**Public Utilities Committee
Public Works Committee
Joint Meeting**

AGENDA ITEM: Discussion and action to make a recommendation to the Village Board regarding the Preliminary Plat proposed as Rosewood Fields Subdivision by Veridian Homes located on Parcel #028/0610-024-8070-0 and #028/0610-024-9501-0 (Town of Dunn, County Highway AB).

PRELIMINARY STORM WATER MANAGEMENT REPORT

OVERALL GRADING PLAN

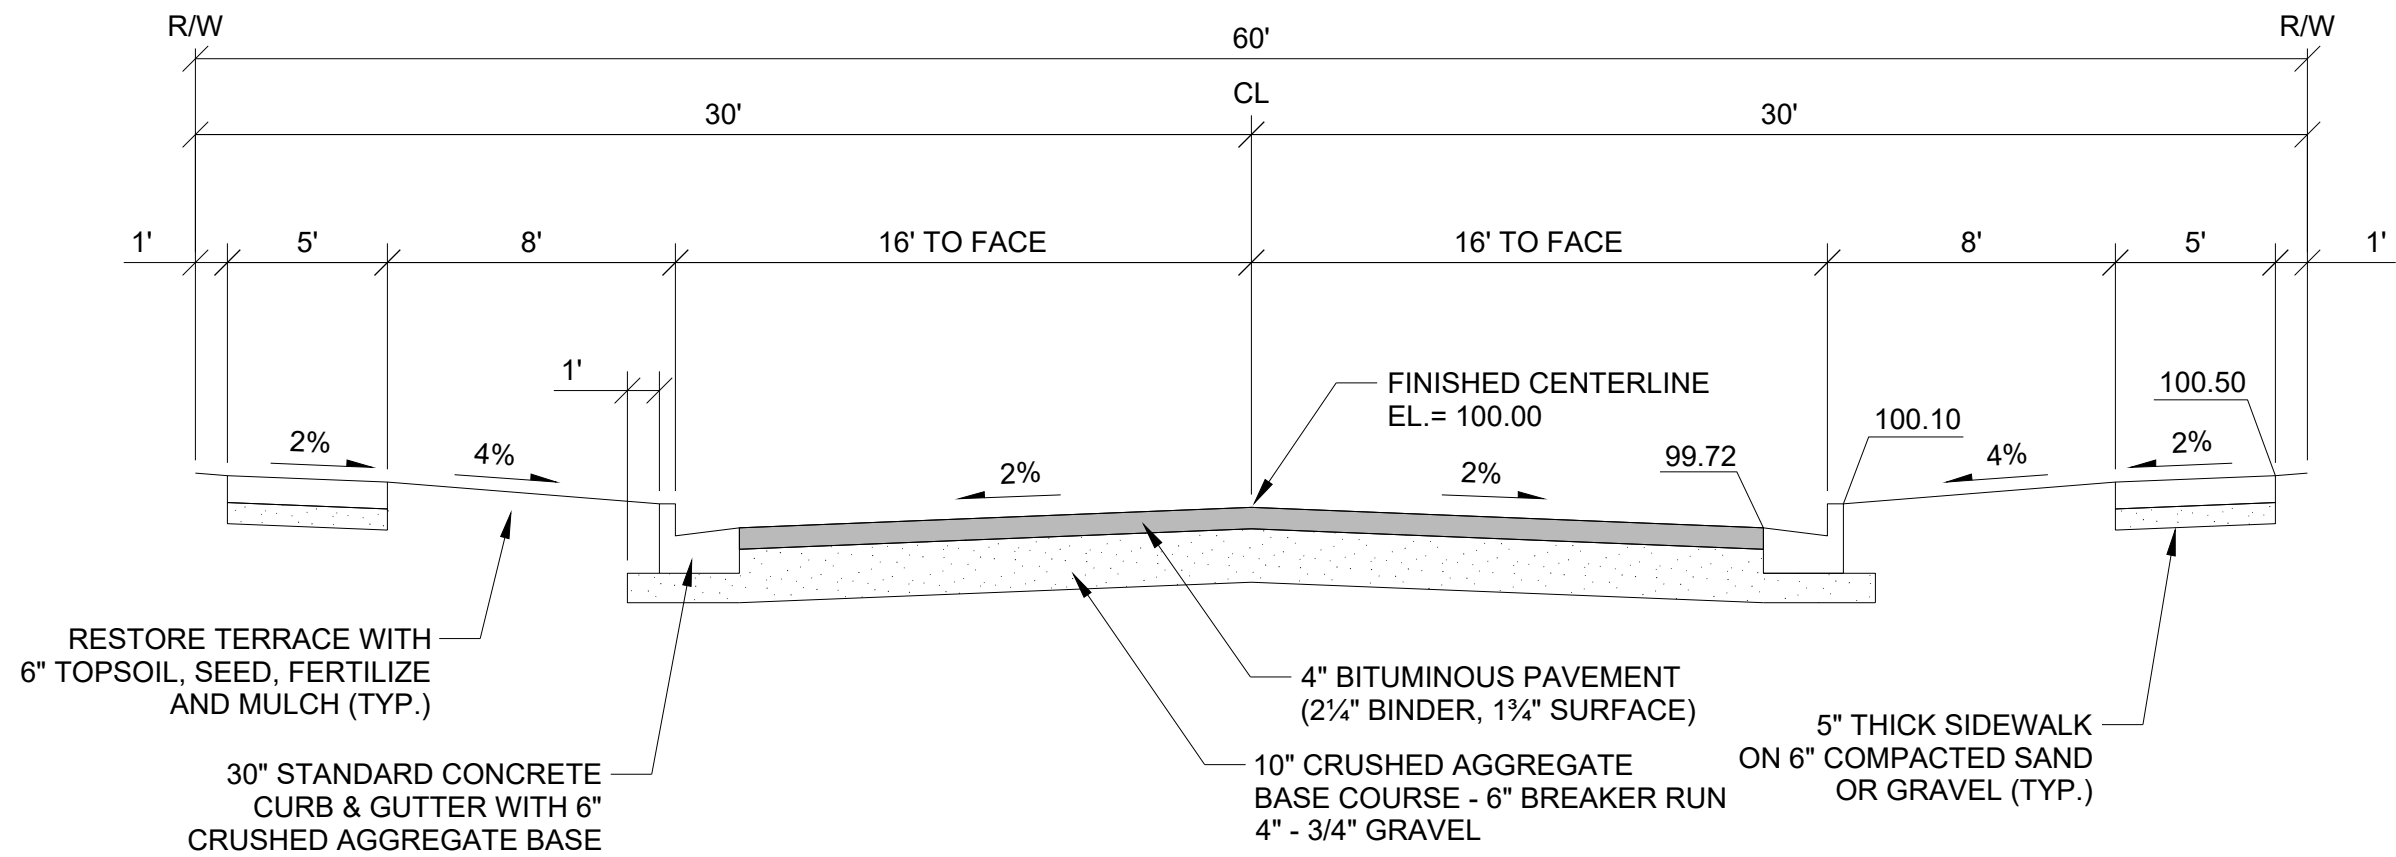
Sheet 2

- Some more detail should be provided showing how the stormwater moves from the west end of Tuscobia Trail towards the railroad tracks.
- There is some concern about preserving as many quality trees when possible. It is recommended to survey the location of existing trees along the west property line of Outlot 1 and identify those that may need removal as part of the construction grading for Outlot 1.

TYPICAL FINISHED SECTION - 60' R.O.W.

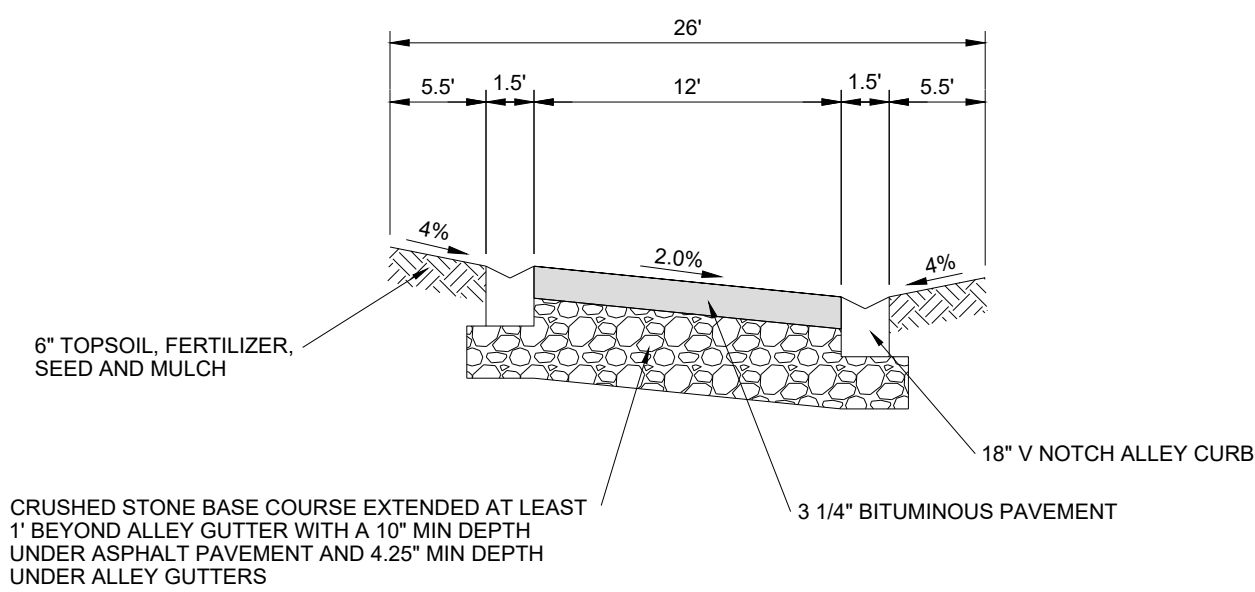
Sheet 3

- The proposed right-of-way width is 60 feet, consistent with Village minimum standards and also recent residential streets. This will allow for on-street parking on both sides of the street and ample (7.5 foot) terrace space for tree plantings, if desired.
